Beaver Valley Power Station, Unit No. 2
Proposed Technical Specification Change No. 75

Beaver Valley Power Station, Unit No. 2 Proposed Technical Specification Change No. 75 REVISION OF TABLE 4.3-1'S TABLE NOTATION (10)

A. DESCRIPTION OF AMENDMENT REQUEST

BEAVER VALLEY POWER STATION UNIT 2 AUTO/MANUAL REACTOR TRIP CIRCUIT

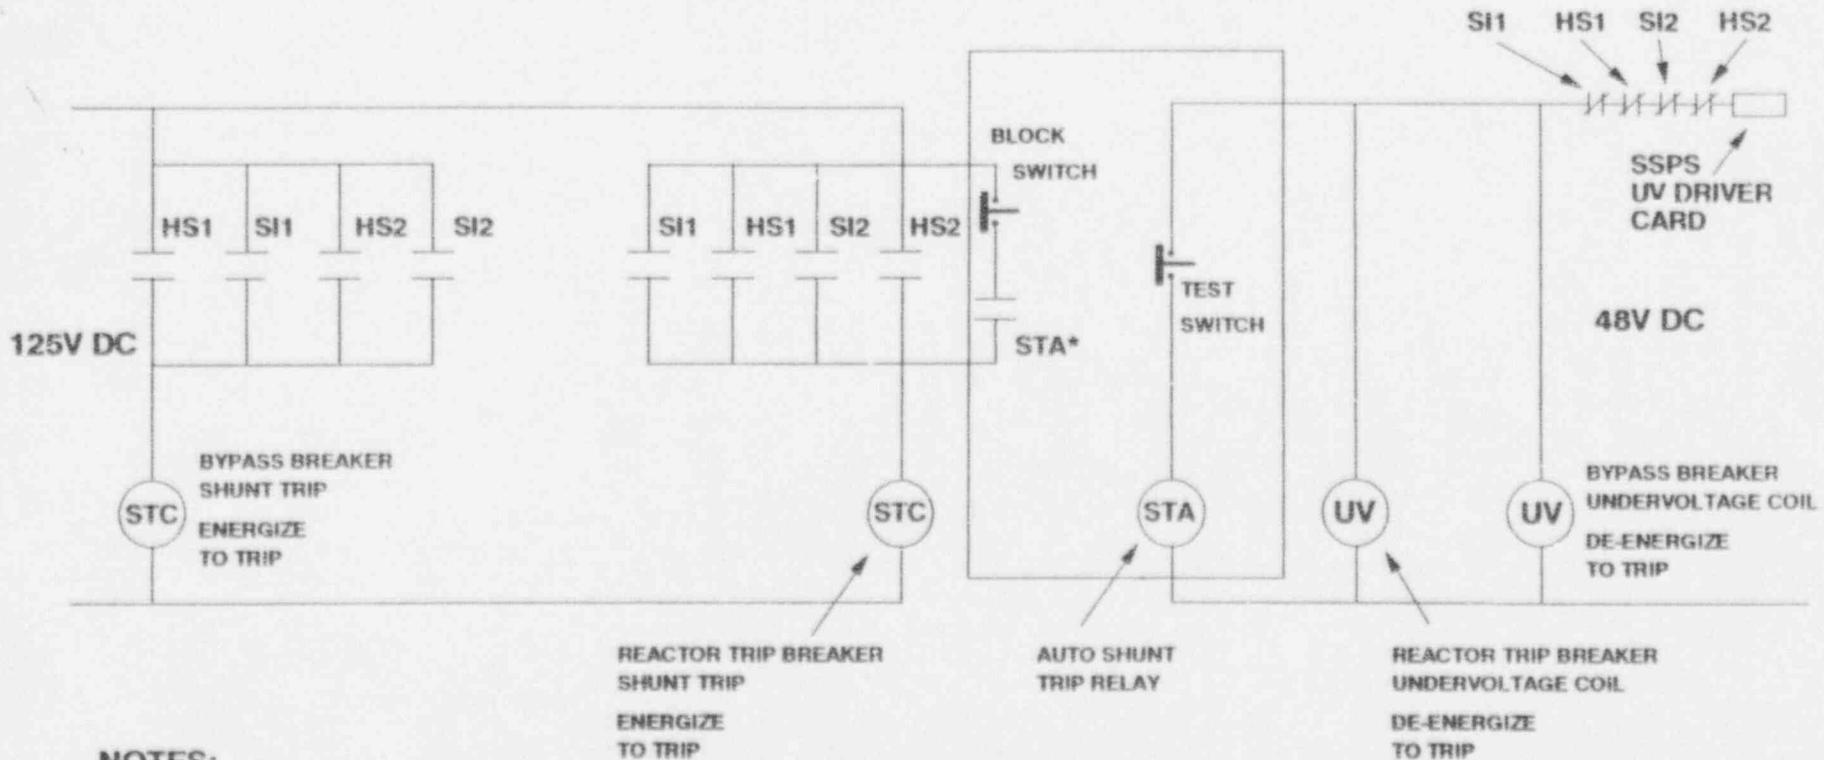
The ability of the Solid State Protection System (SSPS) to initiate a reactor trip via the undervoltage coil and indirectly energize the shunt trip coil has been verified. Should a reactor trip be required, this is the portion of the reactor trip system which would likely function to open the reactor trip breakers. It is unlikely that a manual reactor trip would be required. In the unlikely event that the operator was required to initiate a manual reactor trip and the signal did not reach the shunt trip coil, de-energization of the undervoltage coil would cause the reactor trip breakers to open. Additionally, when the undervoltage coil de-energizes, the auto shunt trip relay (STA) also de-energizes. This action closes a contact which will energize the shunt trip coil and open the reactor trip breakers. (Refer to Figure 1, Attachment D.)

The surveillance testing performed on the reactor trip breakers and the reactor trip bypass breakers was inadequate in that the capability of the manual reactor trip switches, located on the main control board, to directly actuate the shunt trip coil was not positively verified. However, the procedure does verify the capability of the manual reactor trip switches to trip the reactor via actuation of the undervoltage relay. The procedure verifies the operation of the shunt trip coil, however, it does not differentiate actuation from the benchboard switch contacts versus the undervoltage interfacing relay. (See Figure 1 attached.)
